SAFETY RECALL

SR22-310

DATE: August 2022 SECTION: 18 CHASSIS
SUBJECT: USSC REAR BENCH SEAT BOLT MISSING

Figure1

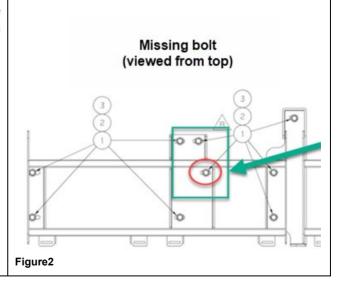
- 1. Remove the seat base from the 2nd curb side rear bench seat (red circle Figure 1).
 - Unscrew the two screws retaining the seat base to the frame (arrows Figure 1).
 - Lift to remove the base and expose the frame structure.

Figure3

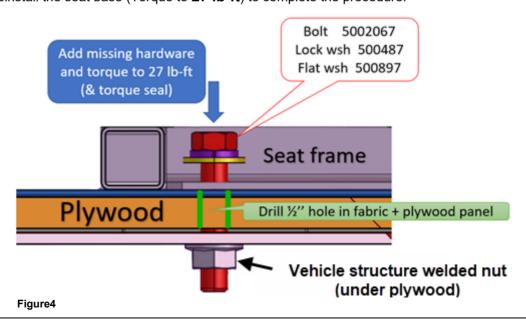
- 3. Drill the missing 1/2in hole in the plywood base using the slot as a guide (Figure 3).
 - Using a cordless drill (or equivalent) and a 1/2 in drill bit, drill through the carpet and the plywood inside the slot to expose the welded nut behind it.

IMPORTANT: Compare with the two top bolts and drill the hole at the same position (left, center or right) in the slot (right position is shown in Figure 3).
